Model: KV-36FS12, KV-36FS13, KV-36FS16
KV-36FS17, KV-36FV16, KV-36FV26
KV-36FV27, KV-36HS20, KV-36XBR400
KV-36XBR450**No. 539****Subject: CRT X-Ray Label****Date:** June 7, 2001**Symptom:**
(118X)

Fig. 2 Mount the X-ray CRT label on the CRT bell.

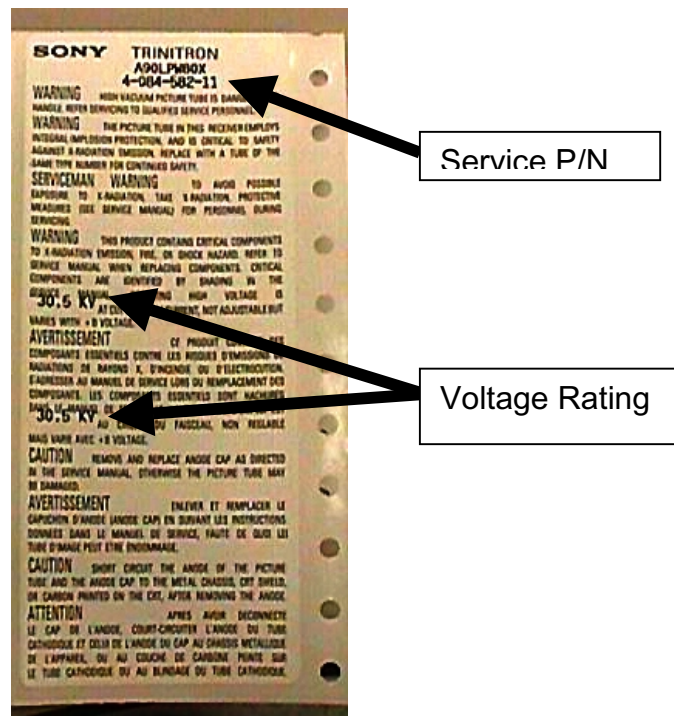
When replacing the CRT if the X-Ray label is not on the replacement CRT then the label below must be ordered and mounted on the replacement CRT.
See figures 1 and 2. For label and mounting locations.

In some cases this label was mounted on the inside of the rear cover. The label can remain there unless the rear cabinet is replaced. In that case the label should be ordered and placed on the CRT.
